MITIGATION PLAN

Final Report for IRT

HUNTSMAN MITIGATION SITE

Subject: Mitigation Plan Report and Construction Plans
Huntsman Mitigation Site, Wilkes County
Yadkin River Basin – CU# 03040102
DMS Project ID #100123
USACE #SAW-2019-00836

Revisions:

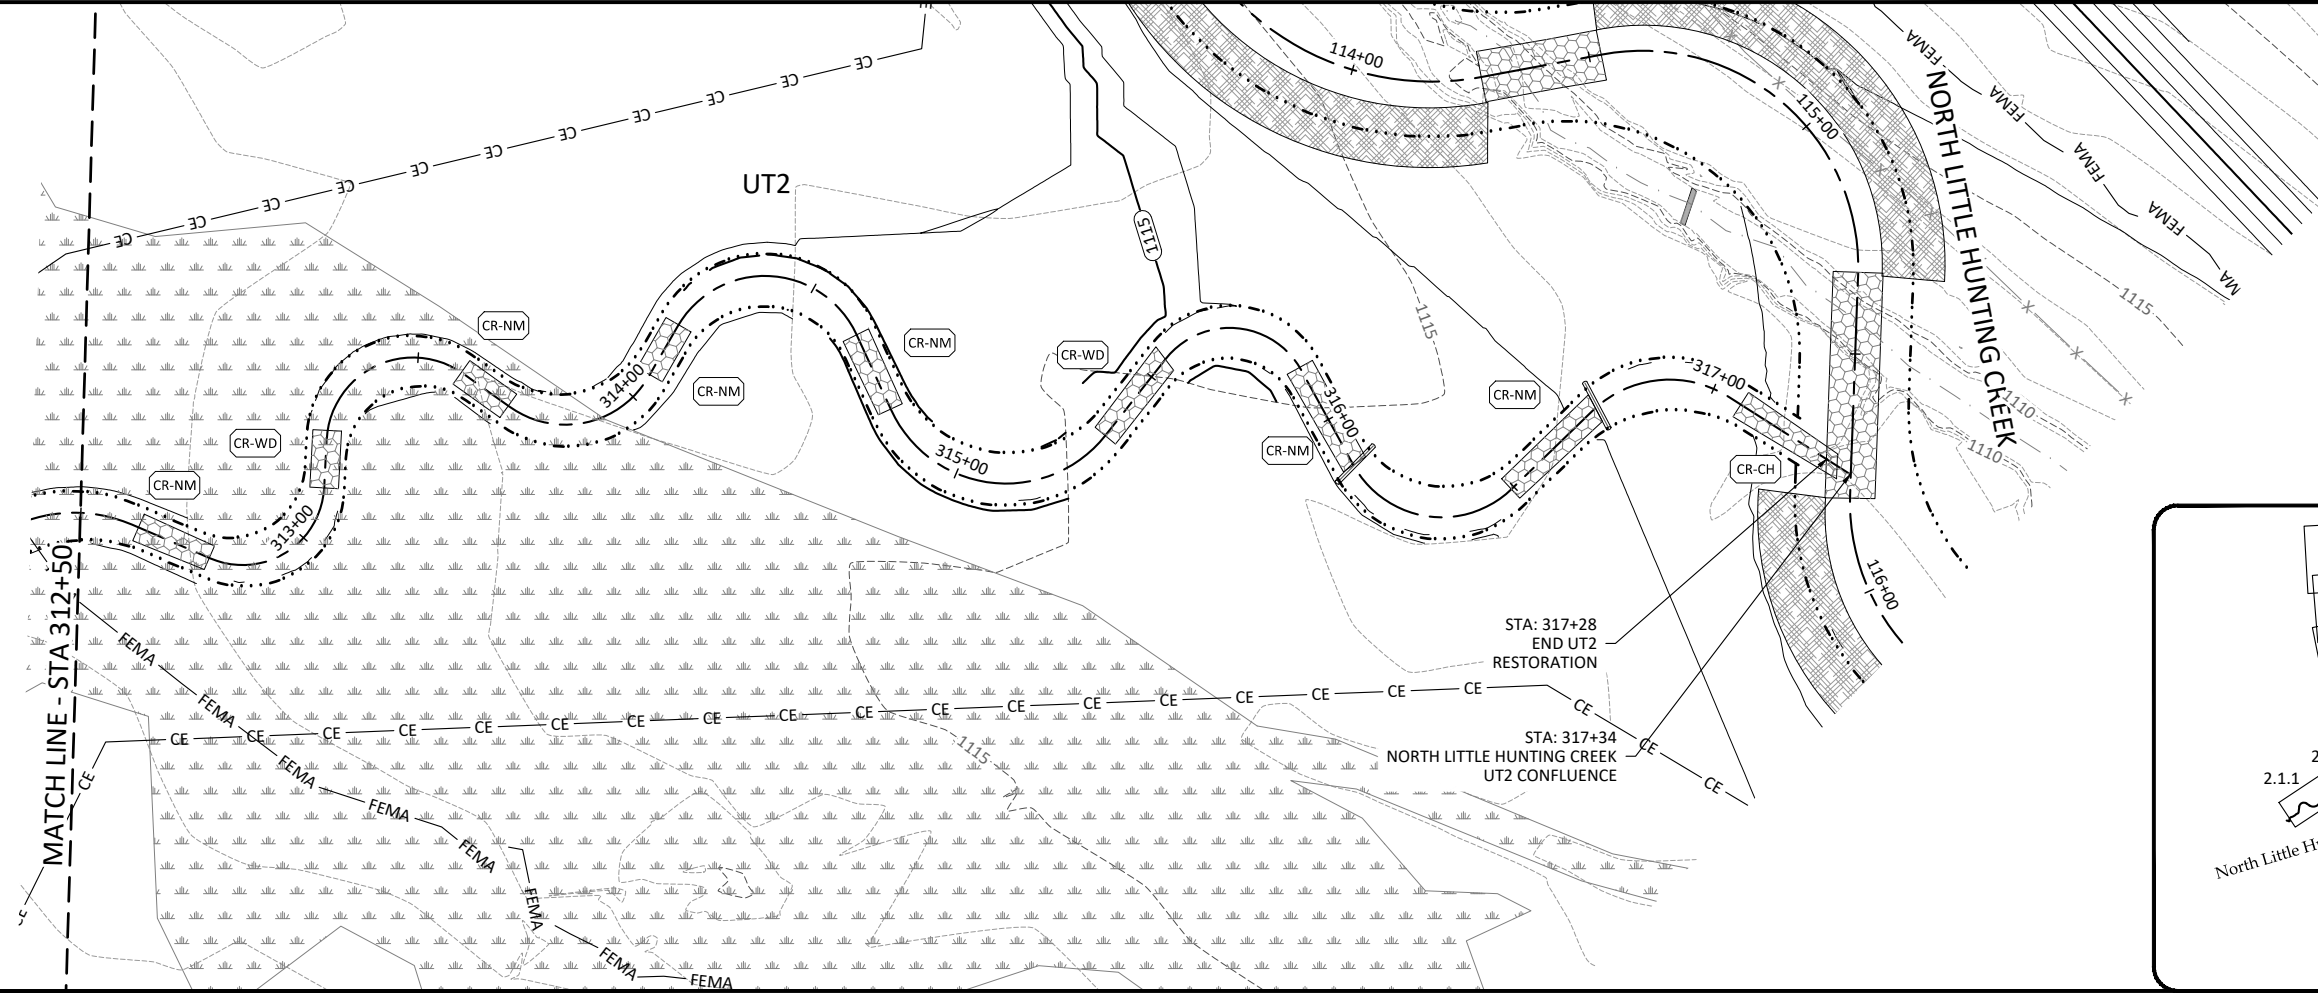
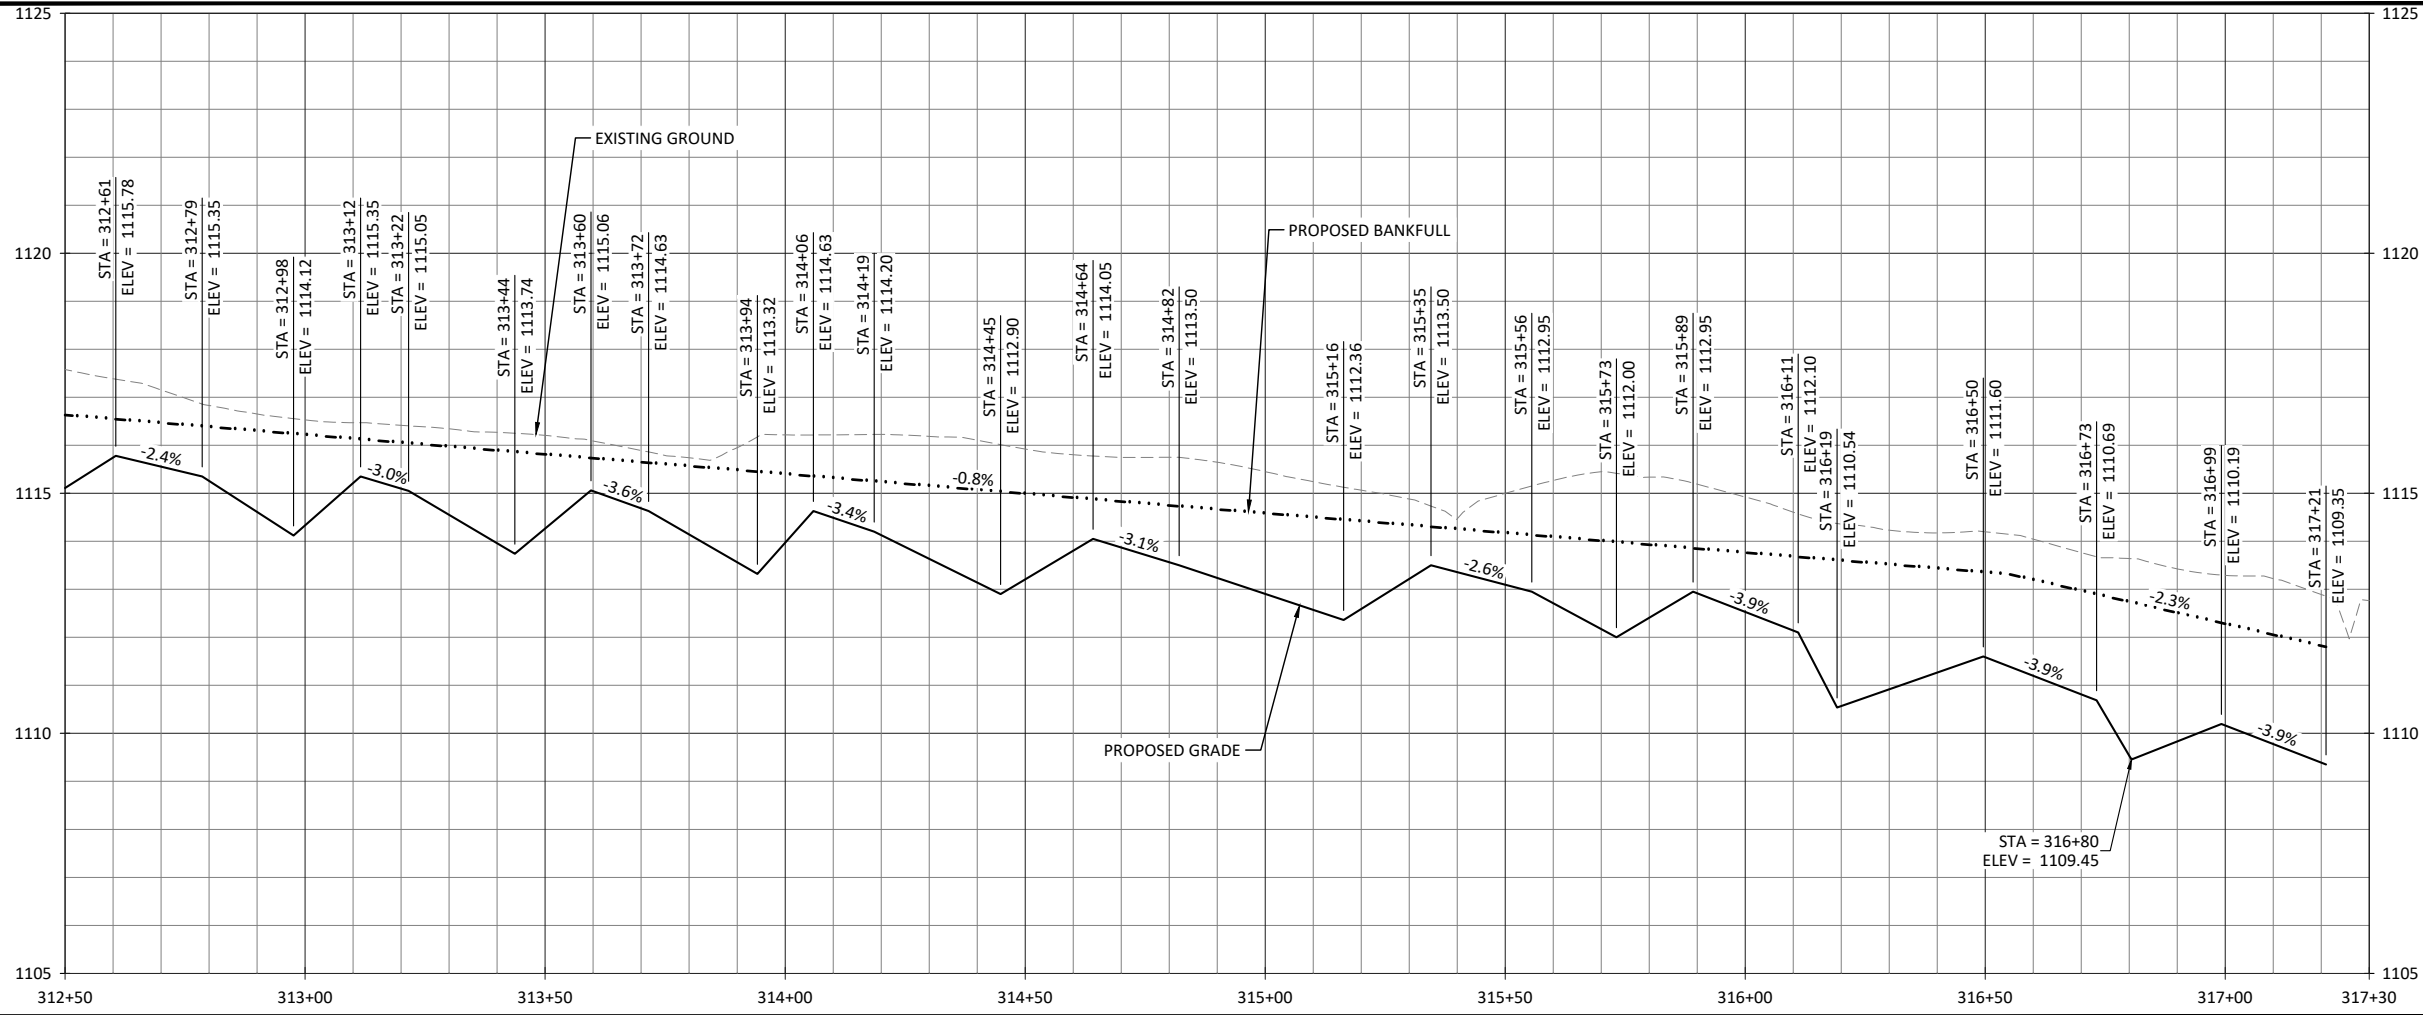
- a) Wildlands acknowledges your above considerations. Please see the response to EPA Comment 1 for additional discussion on buffer width.**
- 18) The inclusion of LiDAR imagery would have been particularly useful especially with regard to UT2 and its proposed restored location.

- a) The topographic map has been updated with LiDAR contours. Please refer to Plan Sheets 2.3.1 – 2.3.4 for detailed topography along UT2.**

Huntsman Stream Mitigation Site
Wilkes County, North Carolina
Plant Lists
Planting Plan

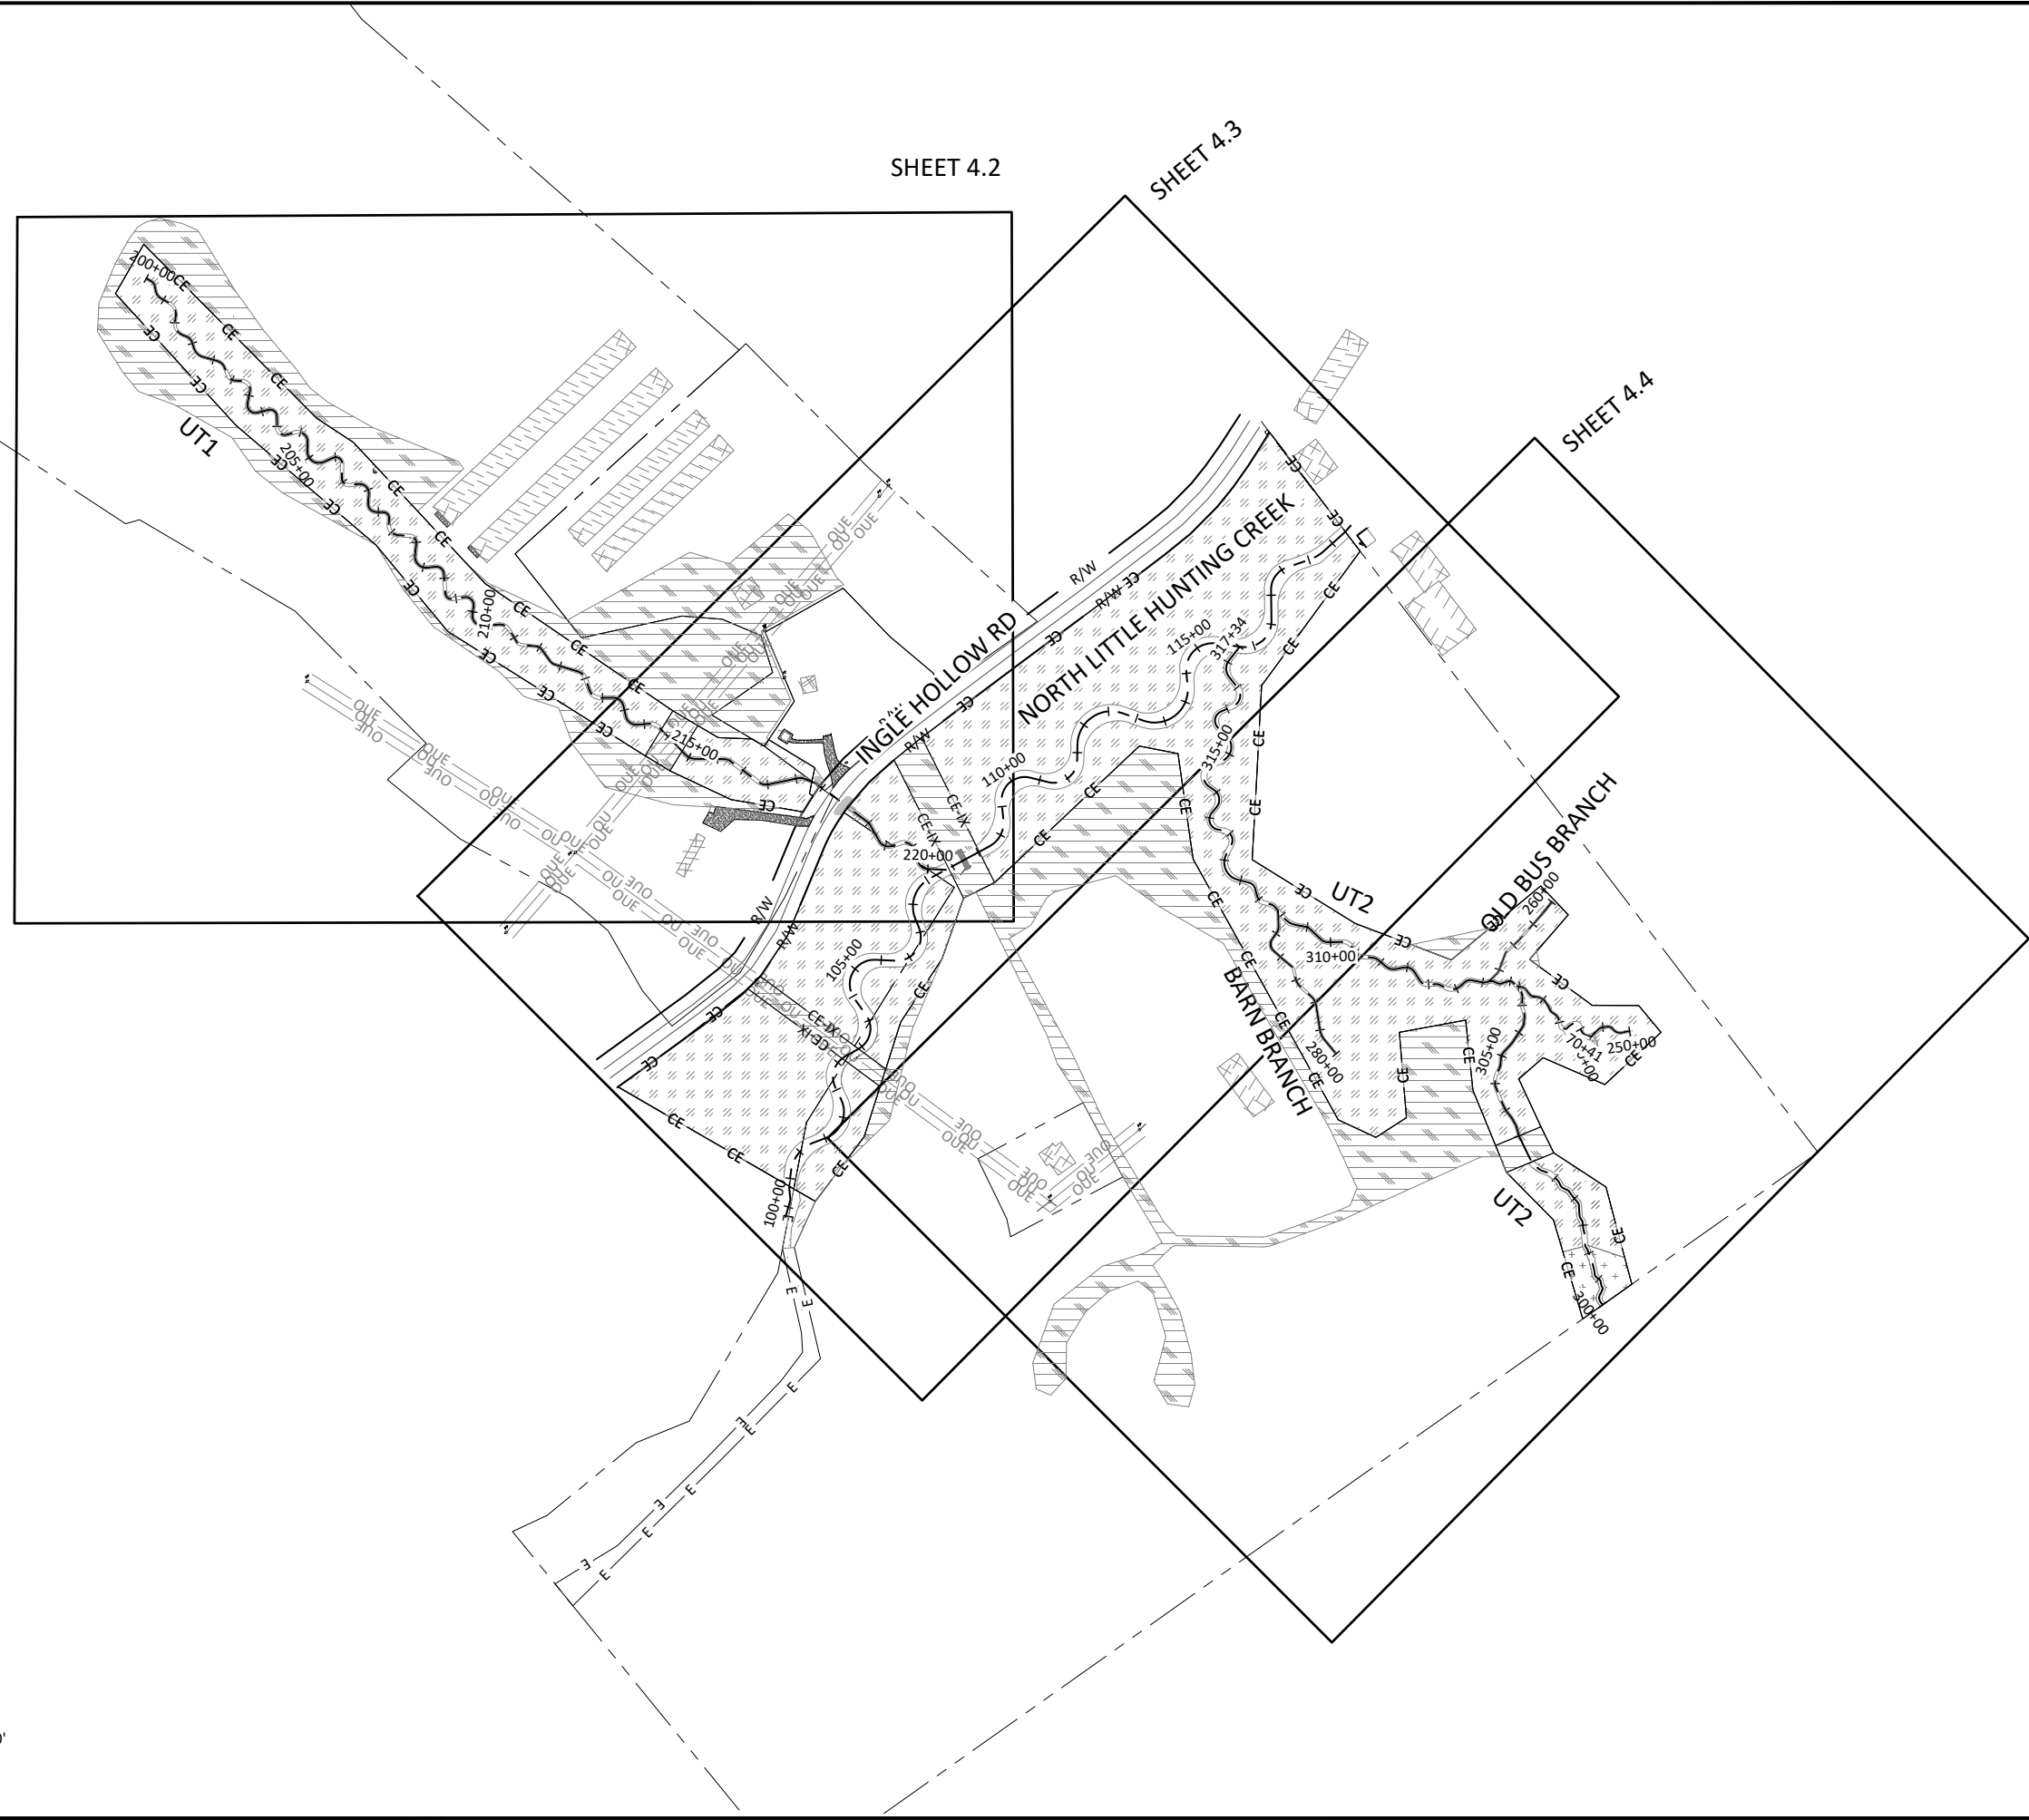
- 11) Sheet 4.0 – Sourwood has the wetland planting asterisk but also has an Upland indicator status. Please double check. Also, American hornbeam has an FAC indicator status.

- a) DWR encourages integrating some of the subcanopy and shrub species listed in the shaded planting zone table into the larger site planting area. If not during the initial effort, then perhaps as part of a supplemental planting effort during monitoring period.

- a) ***Recommended planting density was increased to a minimum of 680 stems per acre on the Planting Plan. Please see plan sheet 4.0 for updated spacing.***

- i) **Wildlands revised the Planting Plan to incorporate more subcanopy and shrub species and revised associated indicator statuses as applicable. Please see the response to WRC Comments 1 through 3 for additional discussion.**
